Federal Recall Information

807-J

Safety recall on certain 135 and 150 gallon fuel tanks

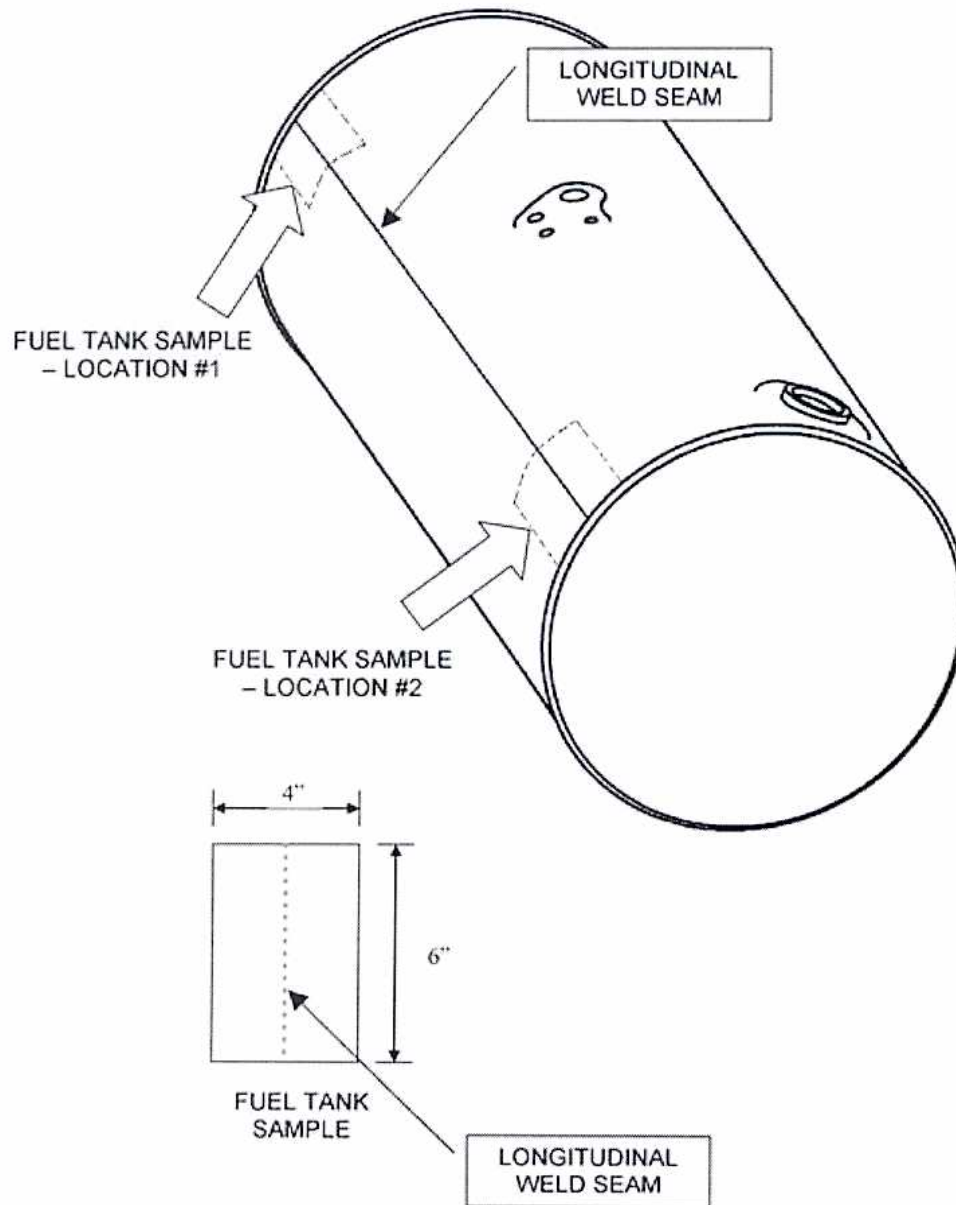
The recall requires that you **return the fill neck and (2) fuel tank samples**.

The fuel tank samples need to have the fuel tank longitudinal seam (and weld material) in the middle of the sample. Please use the following illustration in cutting out the samples.

Make sure each sample is properly identified with the chassis number and the location number as shown in the illustration above.
